BULLETIN # 235-C

CP131

CHECKING/RELOCATING PRIMARY TRANSFORMER WIRING

Fig 1
These wires are too close to the right hand side of the machine.

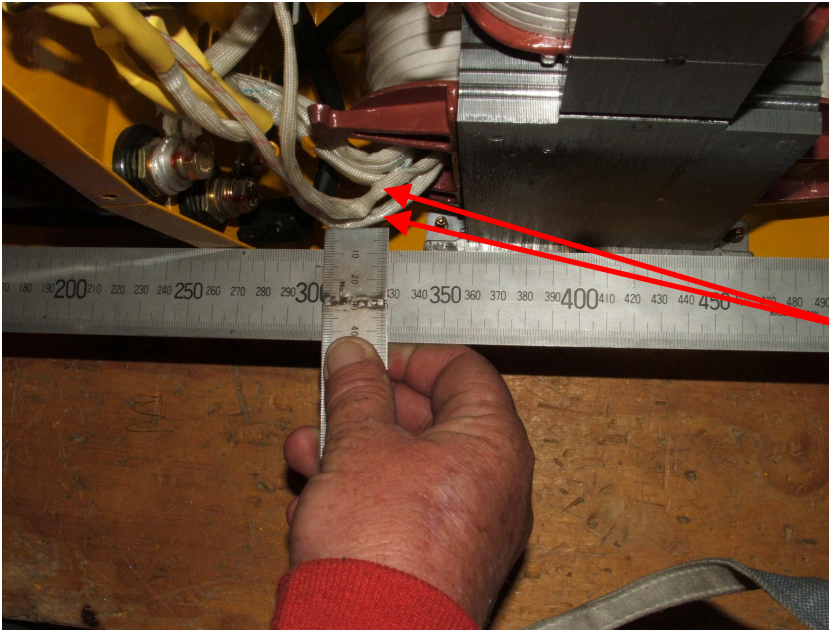
The primary transformer wires which lead to the voltage switches may be located too close to the right hand side panel. If this is the case, their insulation may rub through and the wire may short against the vents in the side panel. This will cause the fuse or circuit breaker which protects the power circuit to trip or blow. Because of the danger which exists if there is a fault in the building earth protection system, WIA have recalled machines which may have this fault present.

Be aware that the vents in the right hand panel protrude approximately 8mm into the machine, so the minimum recommended clearance to the right hand panel (where the vents protrude) is at least 15mm. If the clearance to the side panel is closer than this, the wires must be pushed back toward the centre of the machine.

Fig 2

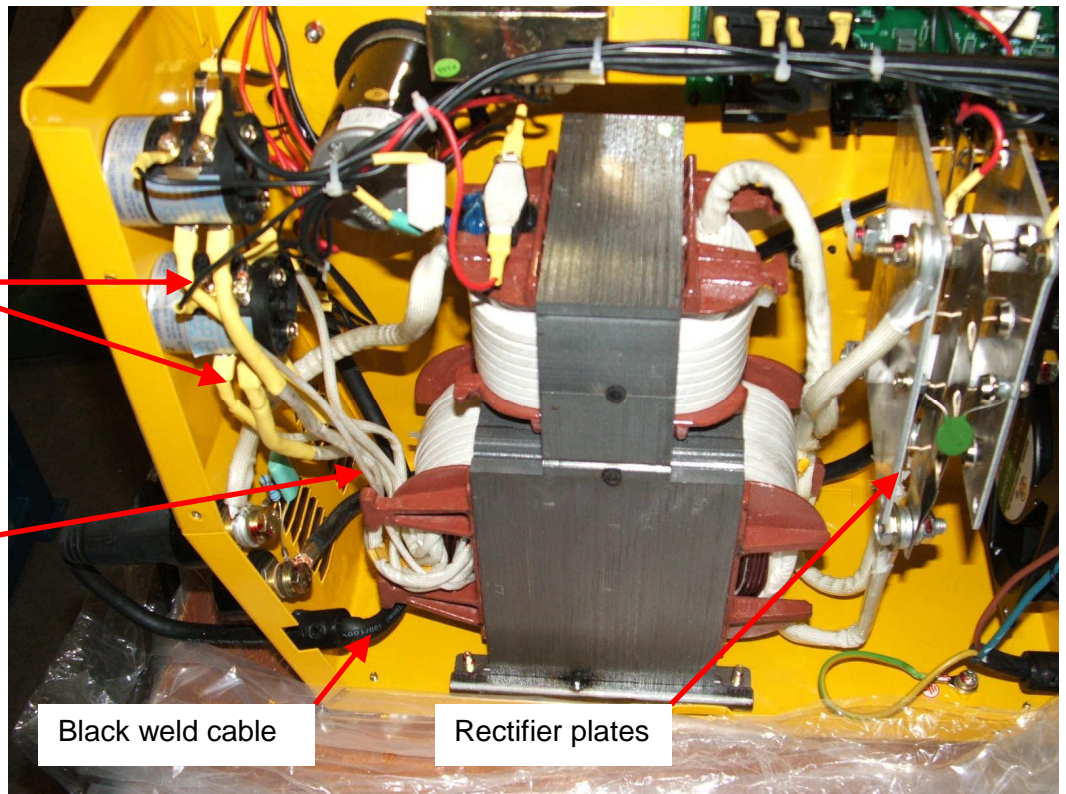
It is recommended that the wires are tucked in behind the plastic bobbin on the transformer, as shown in Fig 2. If this is done, there is no chance that they will come into contact with the machine panels. To achieve this:

Check clearance from wires to side panel here after relocating wires

All the wires are safely tucked in behind the plastic bobbin.

1. Ensure the machine is unplugged from the electrical supply.
2. Remove external covers.
3. Move the black weld cable down and to the rear as per Fig 2 (If not already in this position).

4. Move the primary wires one at a time to their new position as per Fig 2. Be careful that the ends of the cables (where they enter the switches) are not placed under excessive stress while doing this.

5. Check that there is good clearance from the wires to the side panel where the wires enter the switches.
6. The wires are made from stiff aluminium, so it is not necessary to tie them into their new position.

7. Check the clearance from other electrical items (including the rectifier plates shown in Fig 2) to the covers. A clearance of 10mm is required if there are no vents protruding at that particular place. Adjust mounting brackets to obtain correct clearance. Check that the rectifier plates have sufficient clearance to the heat sink on the wirefeed control pcb.
